BikePark Wales

Pre Application Consultation Report

March 2019

Figure 4: Proposed shower and toilet block.

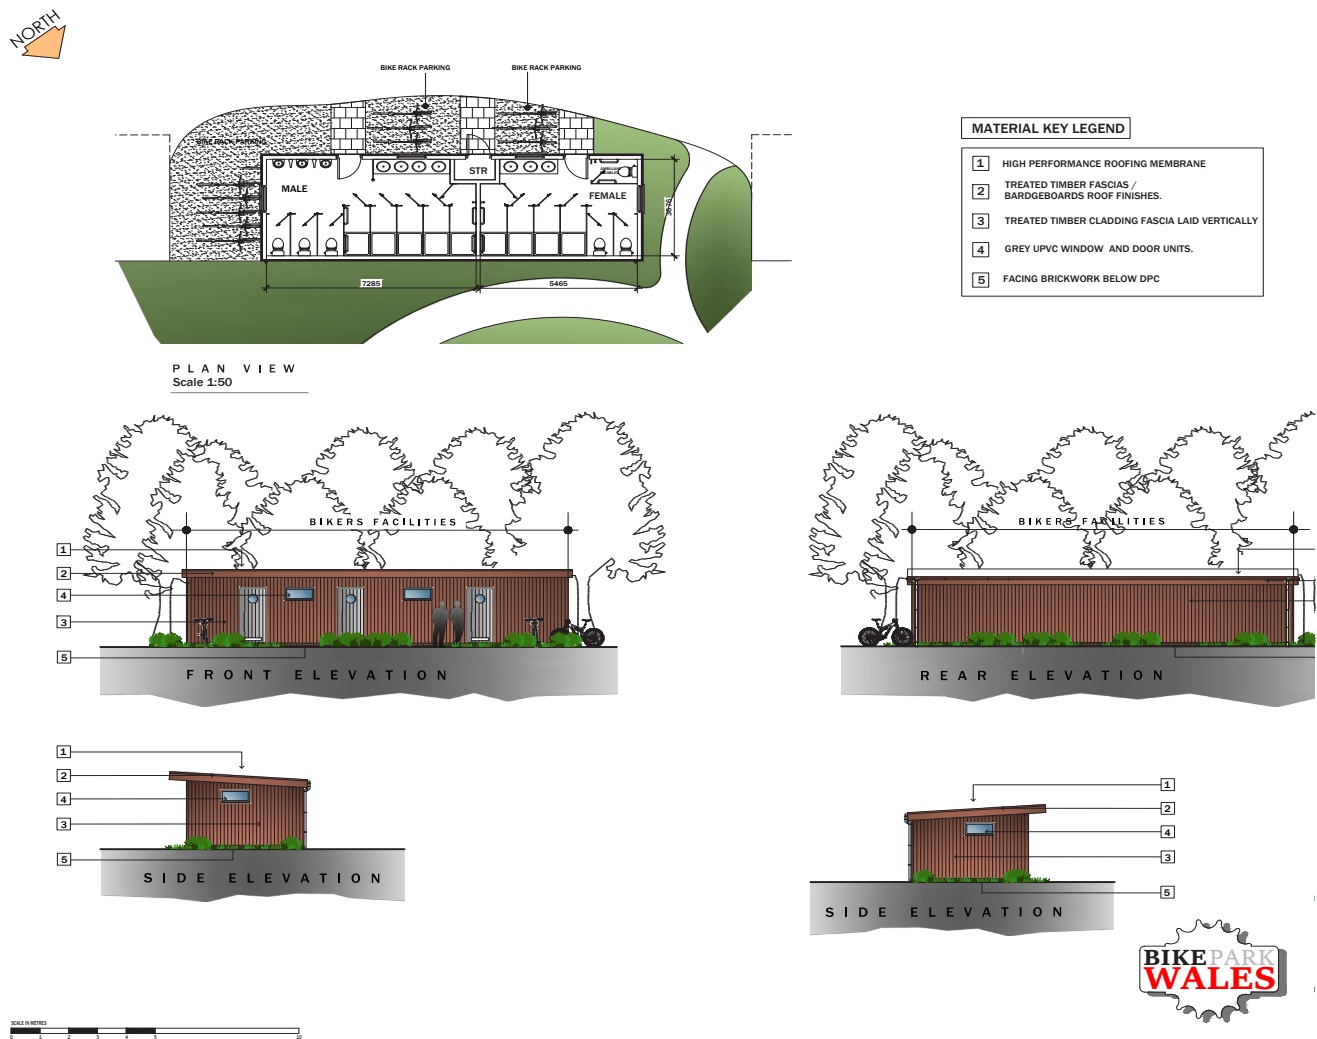
We understand that the intention is to connect the new toilet and shower block to the existing Package Treatment Plant (PTP) through new connections. We also understand that there is an intention to connect the new camping pods and lodges to a new separate system. However, we require further information, to understand if the proposed foul drainage arrangements for the new development are appropriate. These are set out below:

Further information is required to demonstrate that the proposal to connect the new toilet and shower block to the existing PTP is acceptable. This should include the calculation of the combined flow of the watercourse.

We have now amended the design such that the new toilet and shower block discharges to the proposed foul water treatment facility.
